# Florida Power

CORPORATION  
Crystal River Unit 3  
Docket No. 50-302  
Operating License No. DPR-72

Subject: License Amendment Request No. #255, Revision 0  
Emergency Feedwater Initiation and Control (EFIC) System Instrumentation

**LICENSE AMENDMENT REQUEST #255, REVISION 0**  
**Emergency Feedwater Initiation and Control (EFIC)**  
**System Instrumentation**

Figure 1 - Reactor Coolant Pump Power Monitor

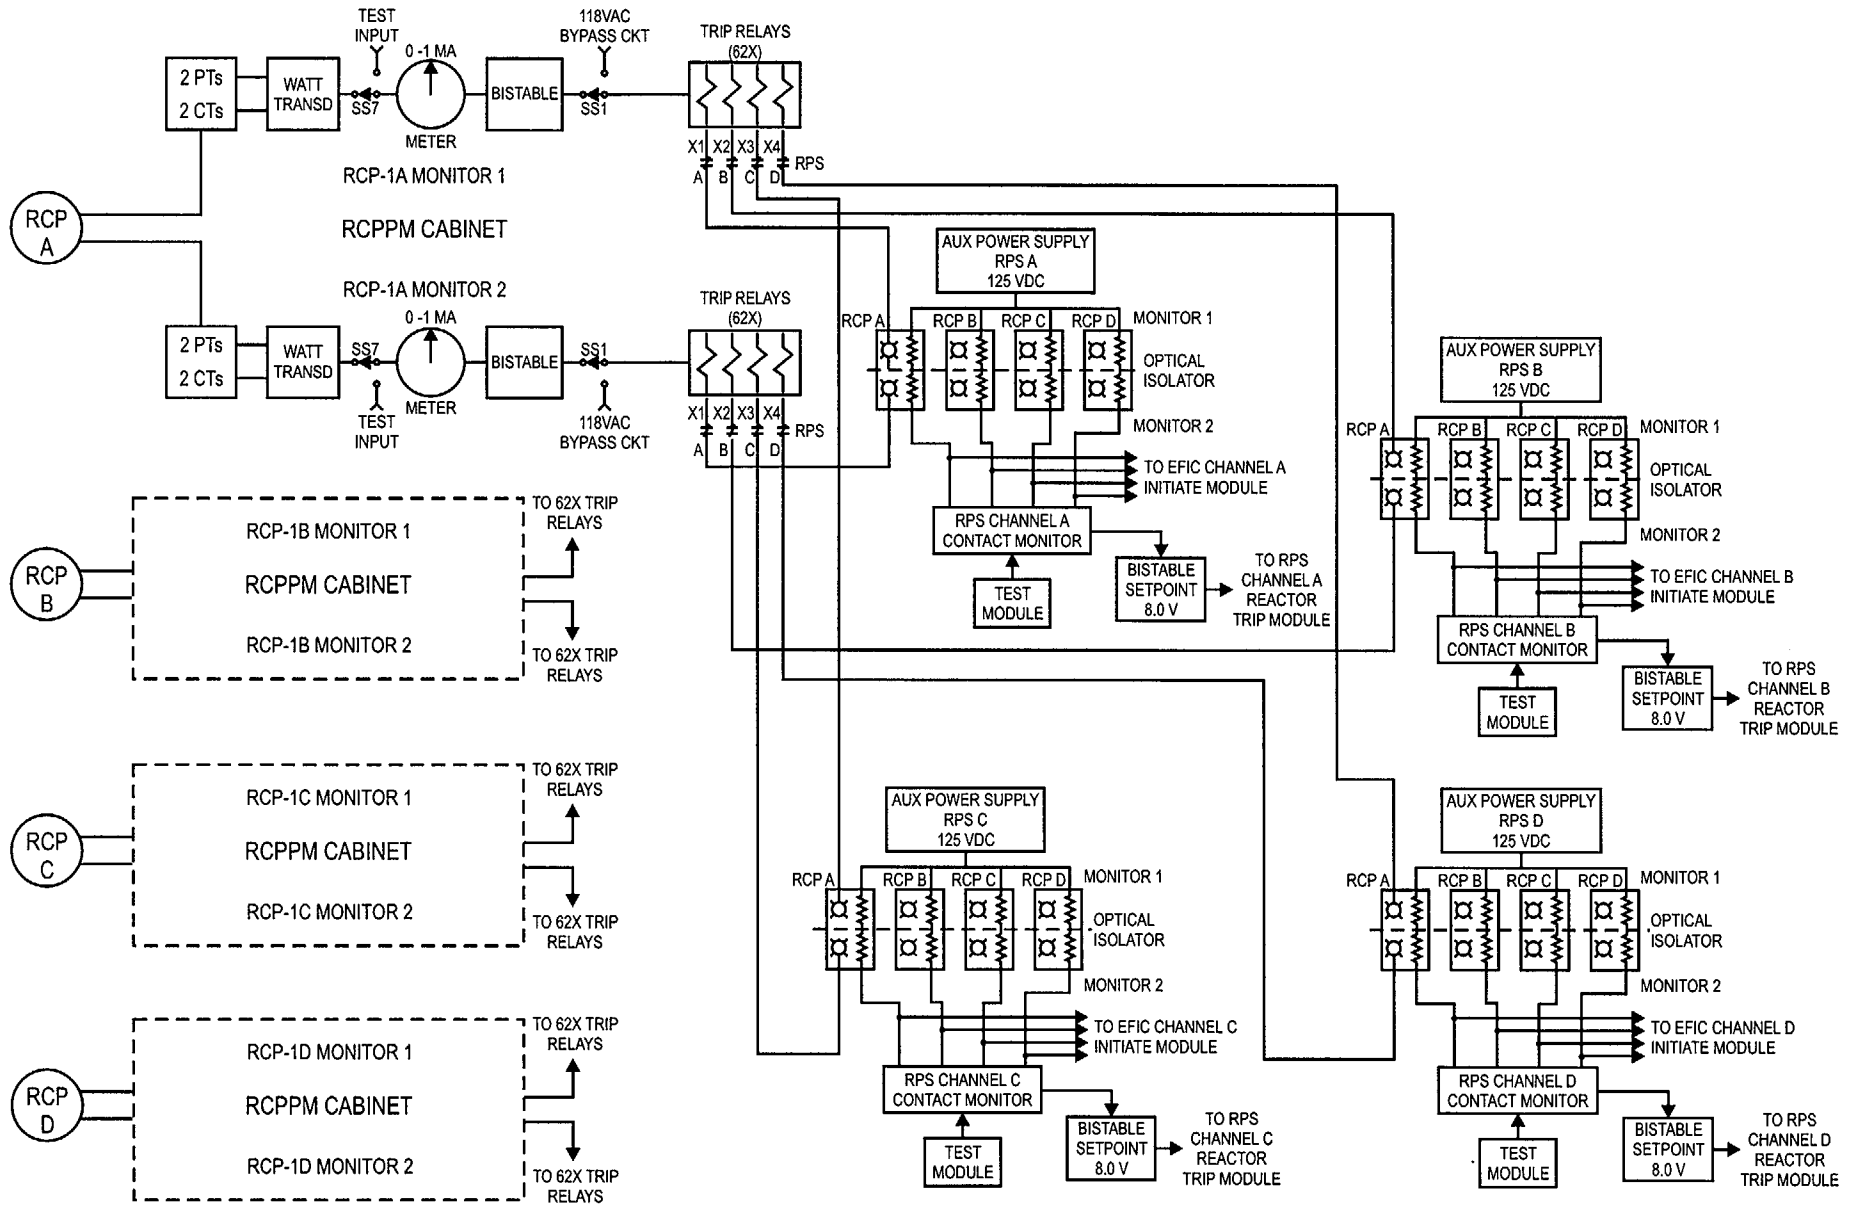
At CR-3, the status of the reactor coolant pumps is monitored by reactor coolant pump power monitors (RCPPMs). The arrangement of the RCPs and the RCP status signals provided by the RCPs to the Reactor Protection System (RPS) and Emergency Feedwater Initiation and Control (EFIC) System are shown in Figure 1.

Each RCP is monitored by two RCPs, configured in a one-out-of-two arrangement. Each RCP contains two watt transducers, which are each fed from two separate potential transformers (PTs) and two current transformers (CTs). If either watt transducer senses an overpower ( $\geq 14,400$  kW) or underpower ( $\leq 1152$  kW) condition for its associated RCP, an RCP tripped status signal is generated. The status signals generated by the RCPs for each RCP are sent to all four RPS channels. In each RPS channel, the status signals divide into two parallel signal paths. One path supplies pump status signals to the RPS channel contact monitor. The second path provides pump status signals to the corresponding EFIC channel initiate module. RPS channel A provides signals to the EFIC channel A initiate module, RPS channel B provides signals to the EFIC channel B initiate module, etc. If the RPS channel contact monitor detects tripped status signals for two or more RCPs, a reactor trip signal is generated for that RPS channel. If the EFIC initiate module detects tripped status signals for all four RCPs, an Emergency Feedwater System initiate signal is generated for that EFIC channel. The two trains of RCPs provide redundancy in that actuation of either train (or combination of trains) accomplishes the safety function of the system.
